Subject: SUBMITTAL OF THE *FINAL FIVE-YEAR REVIEW OF
CERCLA RESPONSE ACTIONS AT THE NAVAL REACTORS FACILITY*

**Five-Year Review of CERCLA
Response Actions
at the
Naval Reactors Facility**

- Appendix A – Technical Re-evaluation of Various NRF No Further Action Sites
- Appendix B - Responses to EPA and IDEQ Comments on the Draft Five-Year Review of
CERCLA Response Actions at NRF

Figure 4-5 NRF-12B/14, NRF-21A, and NRF-19 Engineered Cover Areas

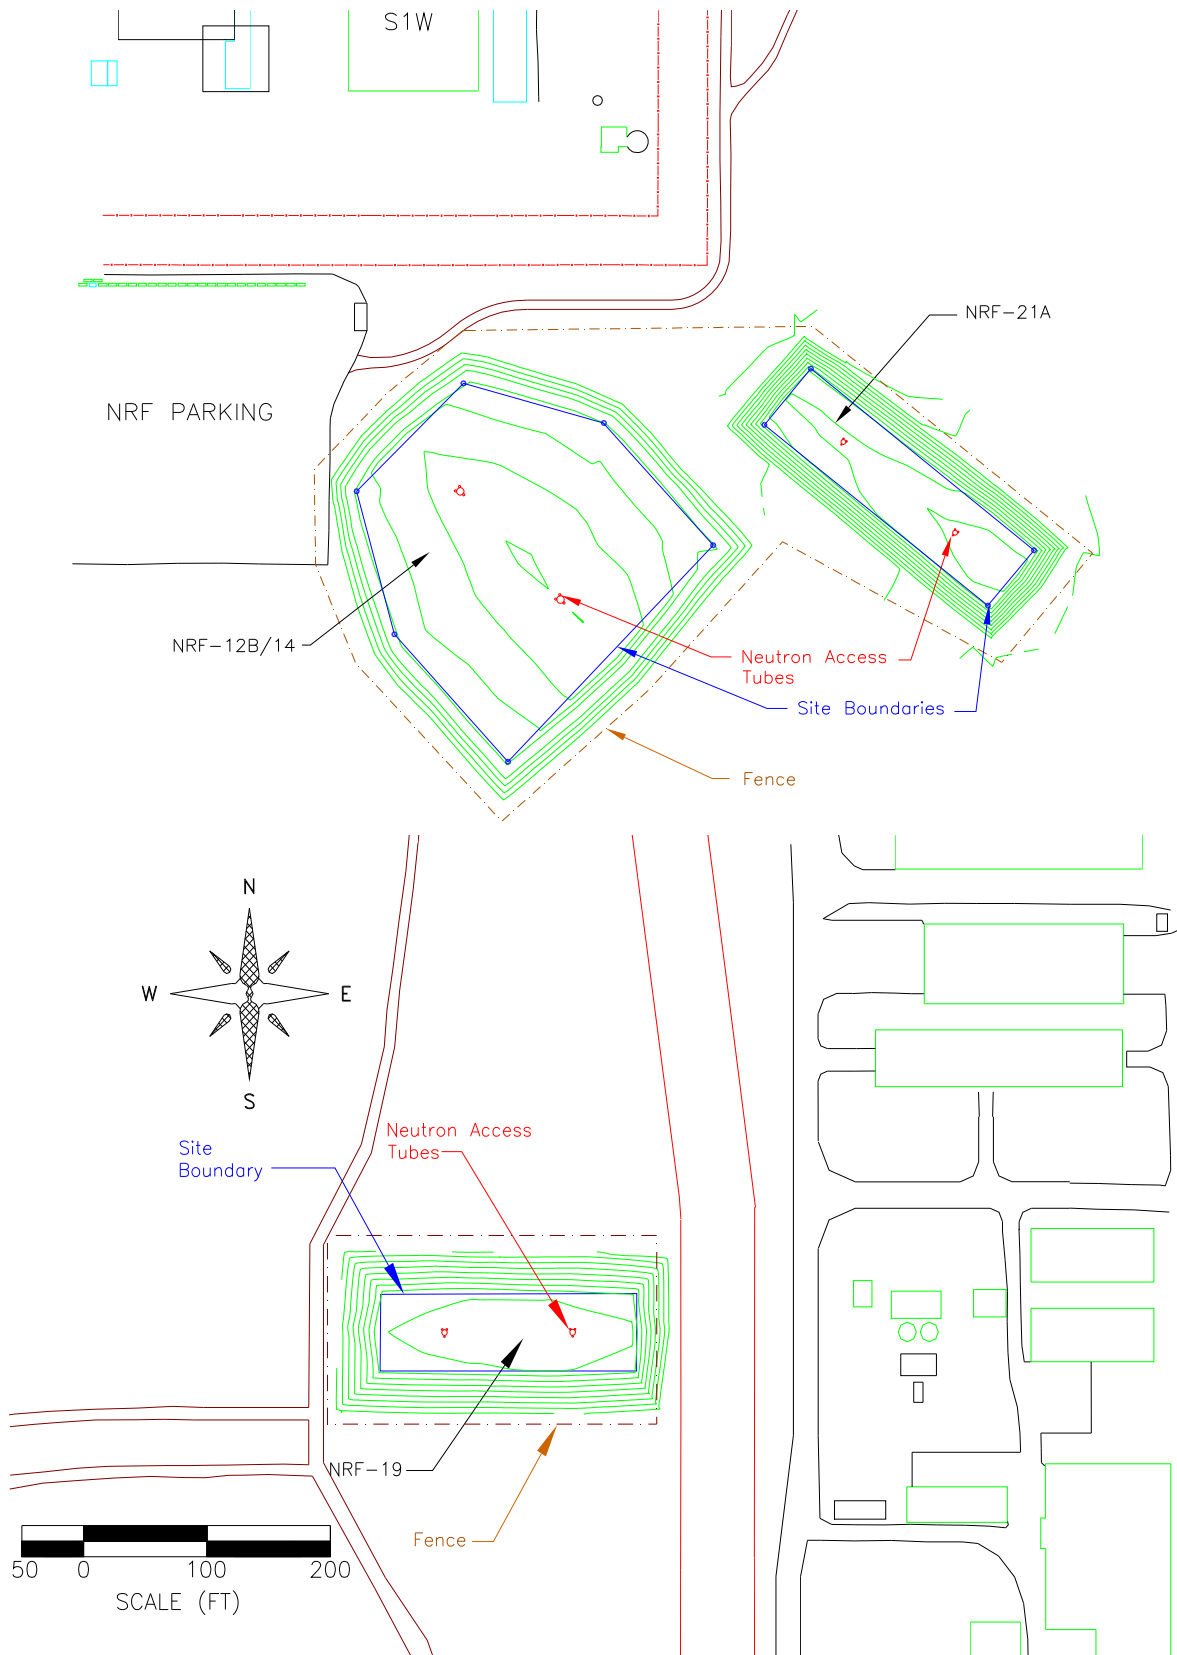
4) **p.51, Figure 4-4;** Please add compass.

Figure 6-1 Comparison of Dissolved and Total Chromium in NRF-6

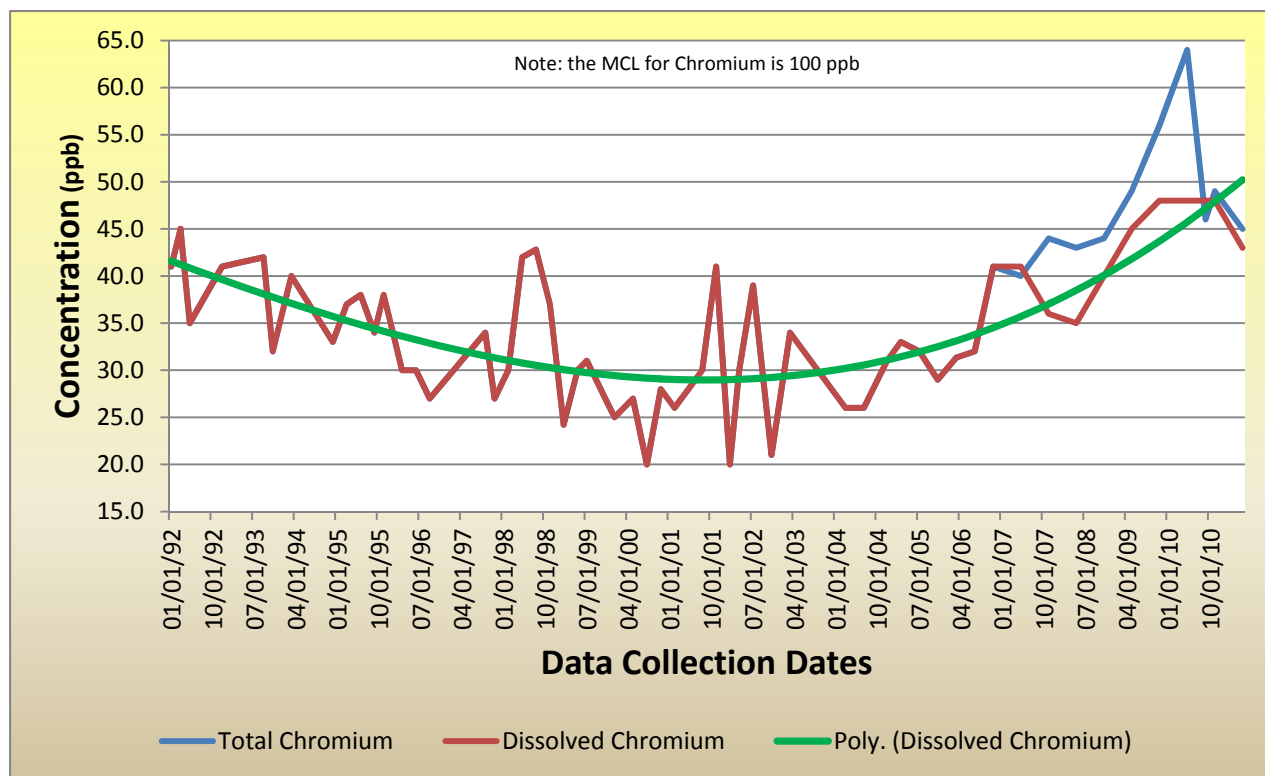
6) **p.63, Figure 6-1;** Please include a reference line on the graph that shows the chromium MCL.

Figure 6-3 Chloride Concentration versus Water Table Elevation in USGS 12

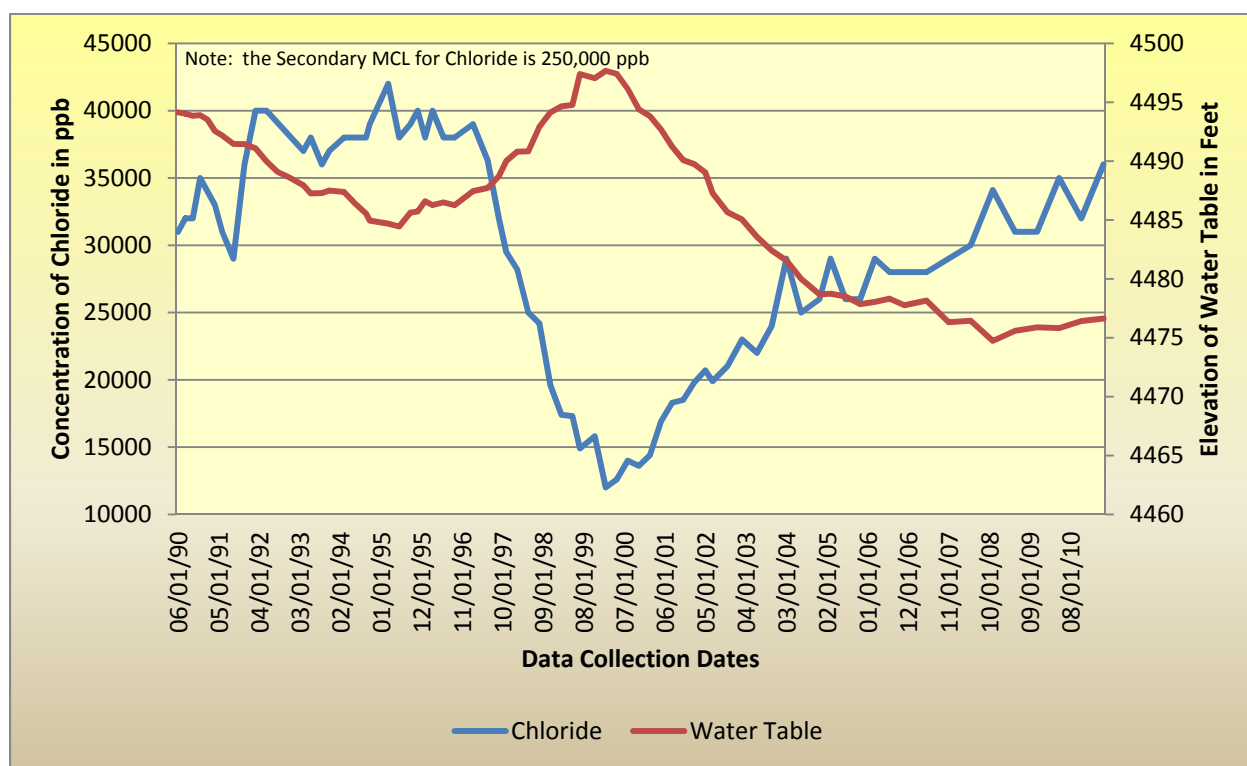
8) **p.75, Figure 6-3;** This graph would be clearer if the y-axis on the right hand side was properly labeled "Water Table Elevation" instead of listing both labels on the left hand side. Please add reference line for Chloride MCL.

Figure 6-12 Soil Moisture Curves for OU 8-08 Engineered Cover Sites -2010

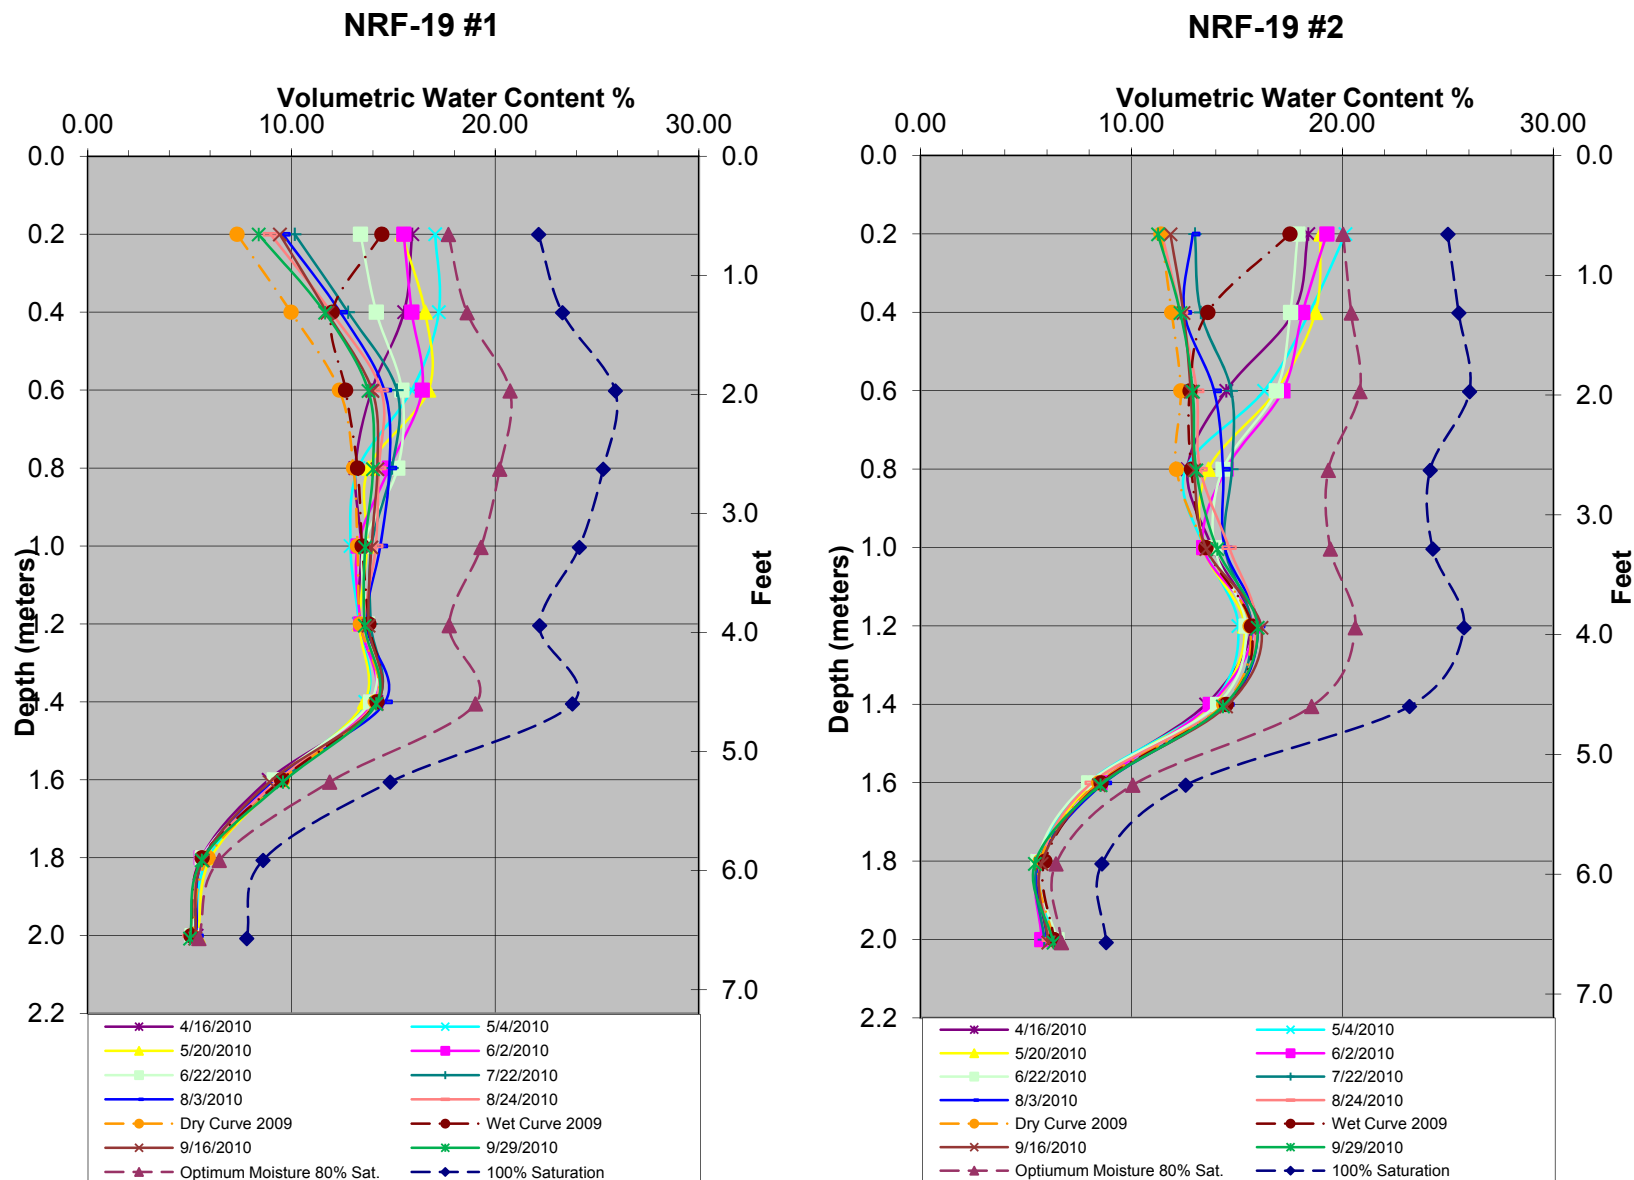
10) **p.91, Figure 6-10, which is now Figure 6-12, Soil Moisture Curve for NRF-21A#1;** Key does not include red/maroon dashed line with triangles ['Optimum Moisture 80% Sat.']*]
